**BUILDING APPLICATION
PLAN REVIEW COMMENTS**

Application #: PB12-01078
Status: ISSUED
Date Submitted: 02/10/2012
Date Issued: 03/09/2012

Address: 11477 WOODLAND SPRINGS DR
Parcel ID: T0973401 Zoning: E
Addition: WOODLAND SPRINGS PLAZA Lot / Block: 1 / A
Legal Desc: WOODLAND SPRINGS PLAZA BLOCK A LOT 1A
Description of Work: ste # 140 / chng retail to fast food/ w remodel/no C/O
ADA TDLR#: Energy Code
Compliant:

PERMIT FOR: Change of Use from Retail to Fast Food Establishment

2/29/12
Revised

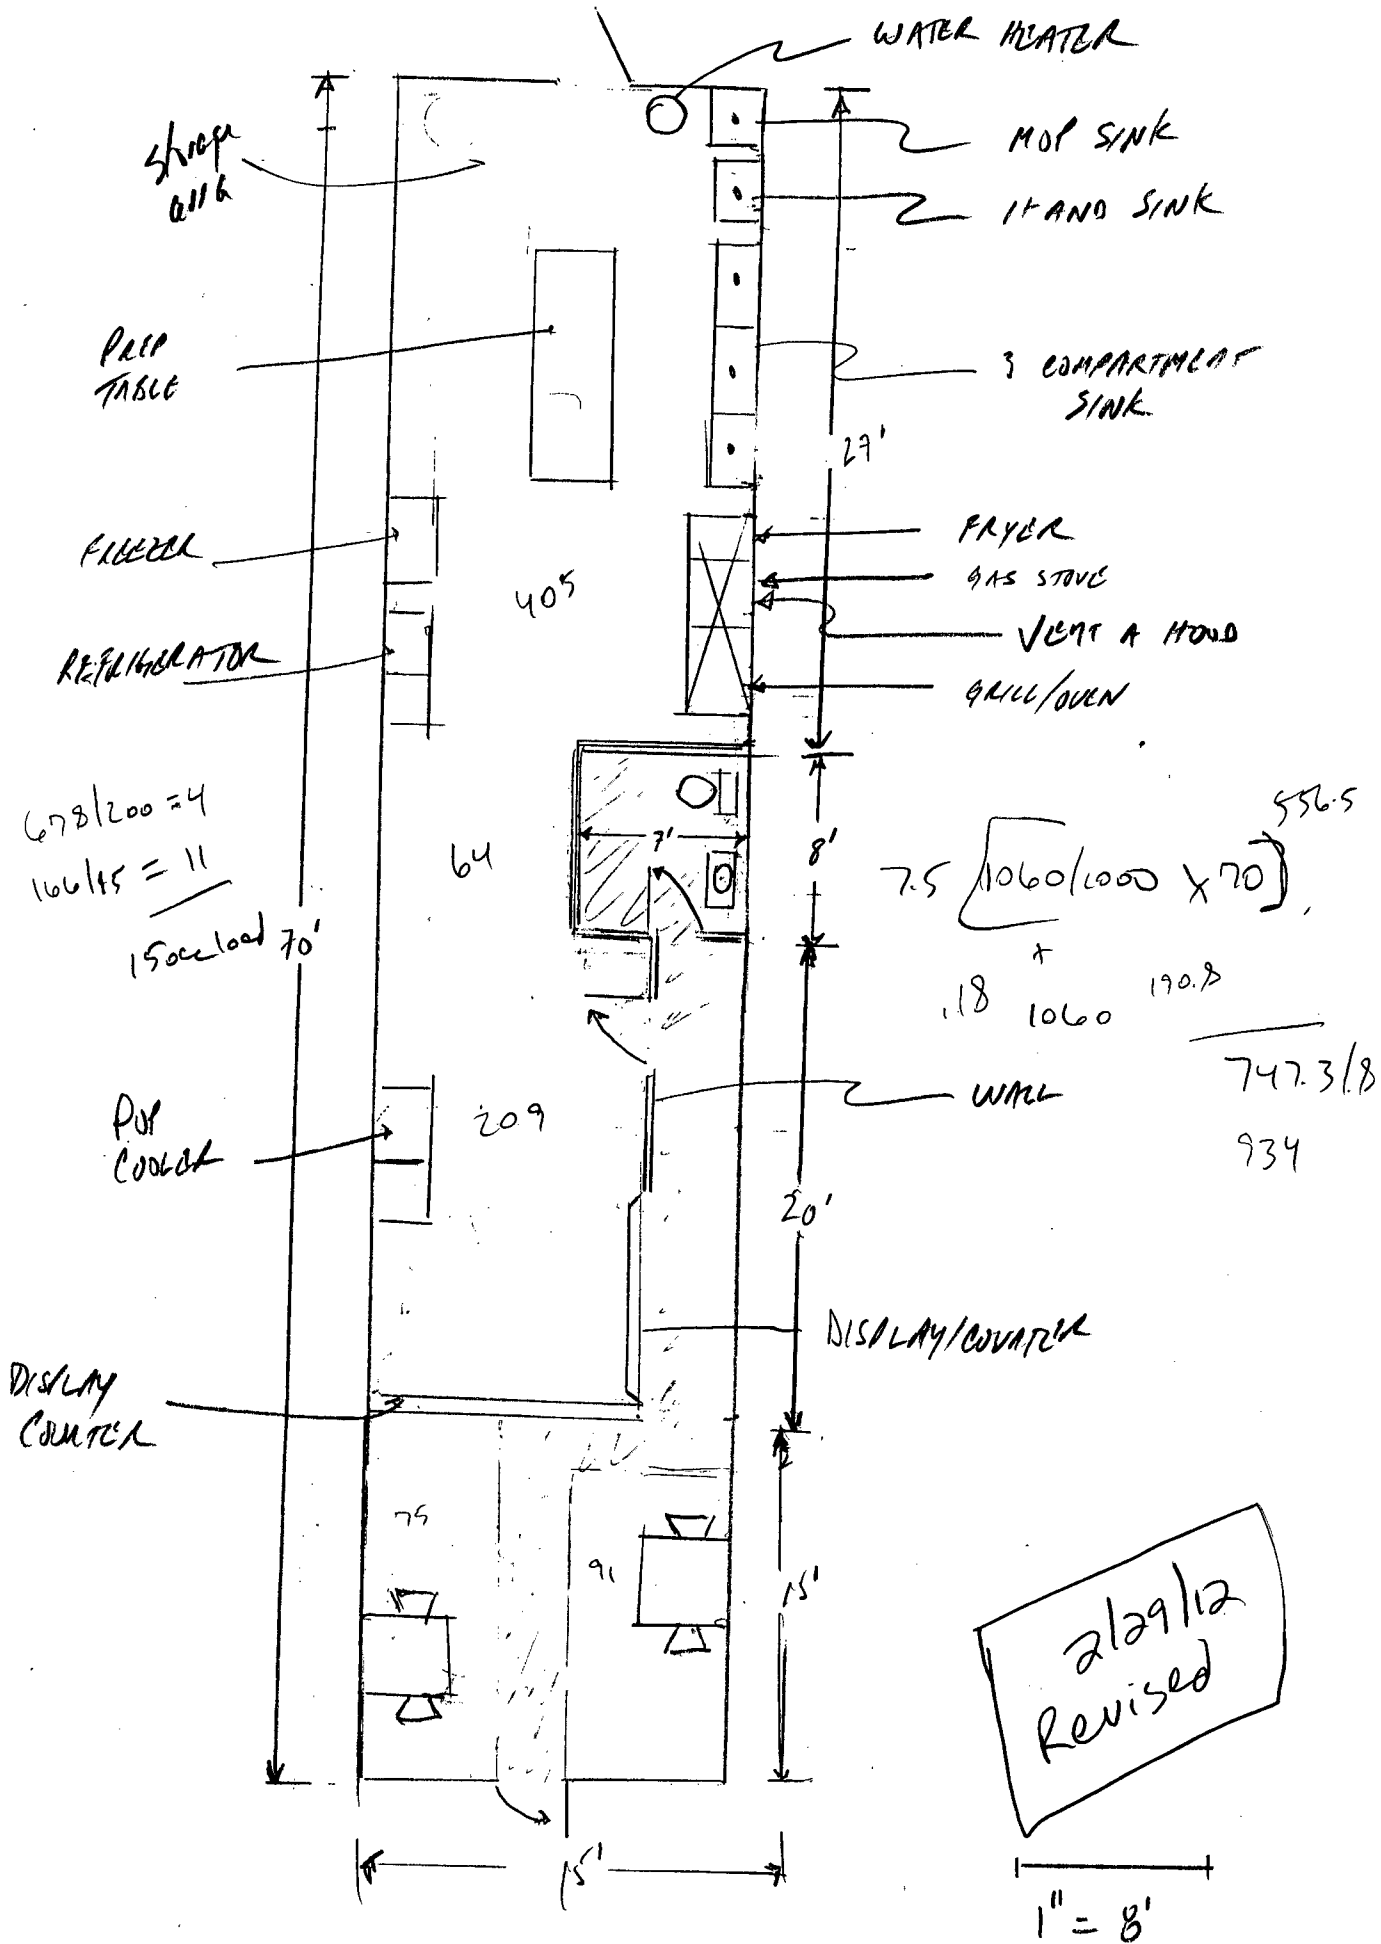
recvd - 2 h/c accessible restrooms are required. Only one is shown on plans. Provide 2nd h/c accessible restroom.....revised floor plan received, occupant load based on the new floor plan is 15
